DRAFT MEMORANDUM

From: John Laplante, P.E., Anchor QEA
Project: 160388-01.01 T02

Re: Final Design - Revised SMA-2 Dredge Plan
Port Gamble Bay Cleanup Project

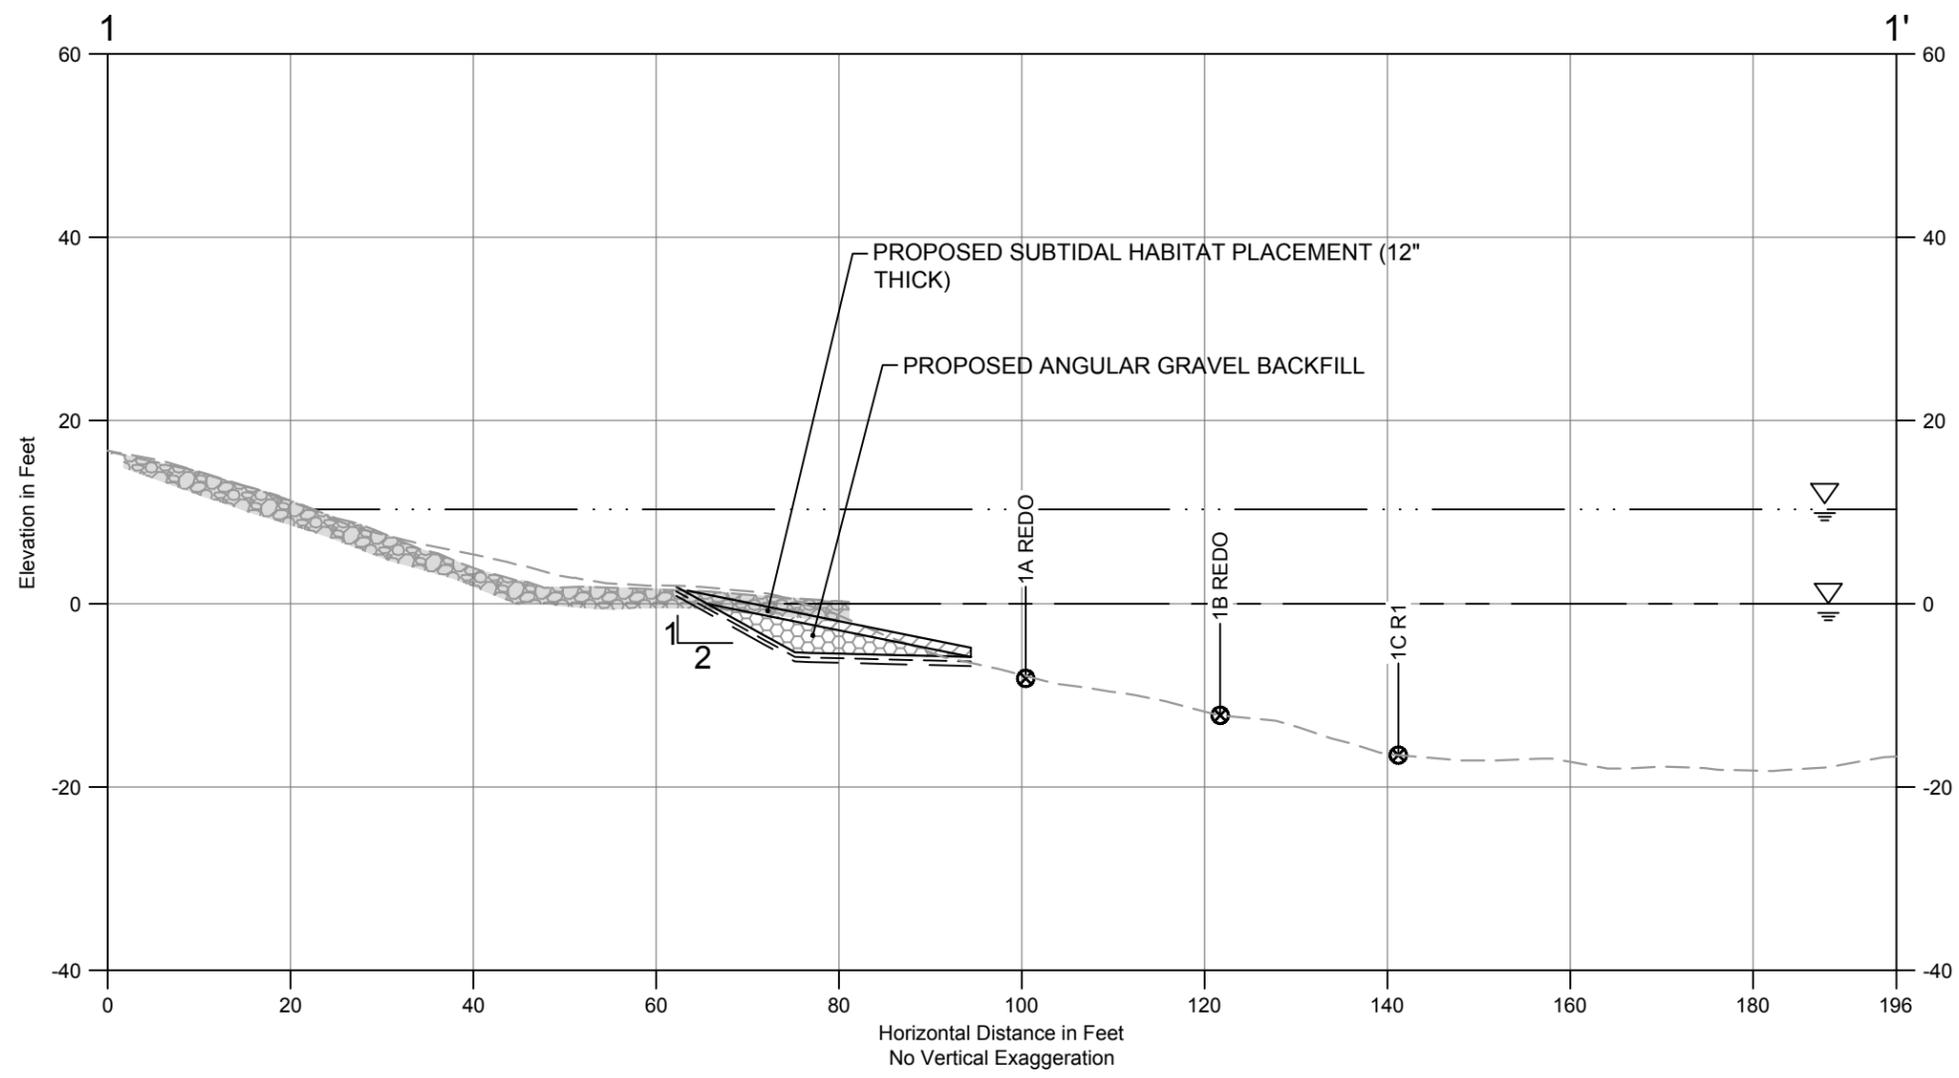
The final design uses dredge cut side slopes of 2 horizontal to 1 vertical (2H:1V) and 2.5H:1V, depending on location. Where the steeper 2H:1V dredge cuts are used, the slope will be backfilled using angular gravel with a 1-foot thick rounded substrate habitat overlay, to a final slope configuration no steeper than 2.5H:1V. Figure 1 presents a plan view of the final dredge prism design, and Figure 2 through Figure 10 presents cross sections for Transects 1

The plan view on Figure 1 and cross sections for Transects 6, 8 and 9 present in concept where a contingency caps could be installed if further removal below elevation -35 feet MLLW is not practicable due to slope stability concerns.

Figure 7
 Transect 6
 Port Gamble Sediment Remediation

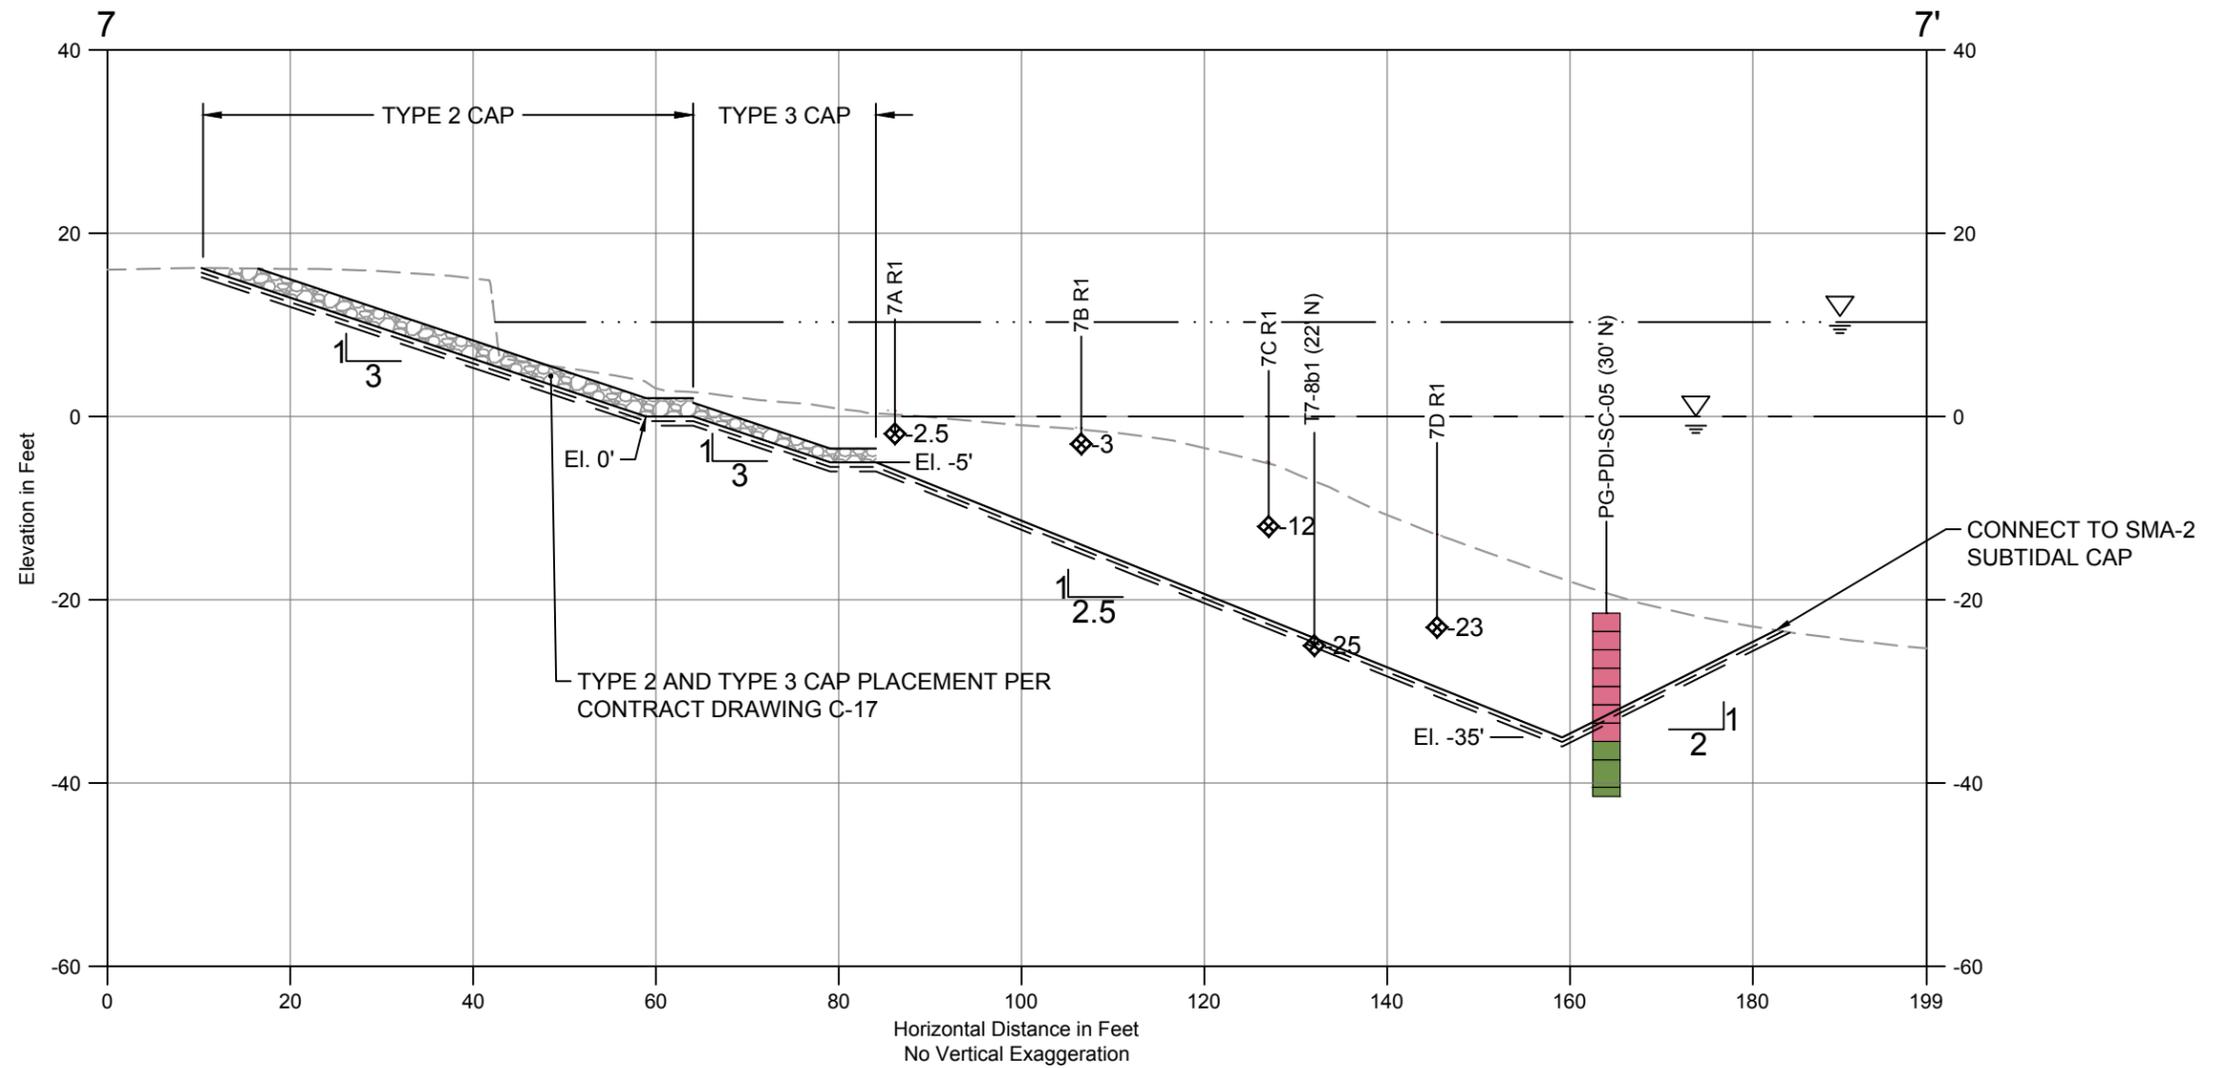
Dredge cuts will be verified with post-dredge core sampling consistent with the procedures presented in the CQAP. It is possible that some areas of deeper wood waste may be encountered during the dredge cut verification sampling in deeper water areas – for example in Transects 6, 8 and 9. In the location of Transects 6, 8, and 9, additional excavation significantly below the target elevation to attempt to remove deeper wood deposits could potentially destabilize the dredge cut slope. Thus, if post-dredge sampling indicates that a substantial thickness of wood waste remains below elevation -35 feet mean lower low water (MLLW), the following contingency options will be reviewed with Ecology and employed as appropriate:

- In relatively level areas at the toe of slope, the contingency would be to install the 4-foot-thick SMA-2 subtidal sand cap, consistent with the design approved in the EDR for other deep subtidal areas in SMA-2. In cases where the contingency cap will be
-

- Where deposits are encountered mid-slope, angular gravel material is needed for a contingency cap to be stable. For slope areas, the contingency cap would consist of 6 to 9 inches of Type 3 armor rock (as described in the EDR), covered with a 1-foot-thick overlay of rounded habitat substrate.
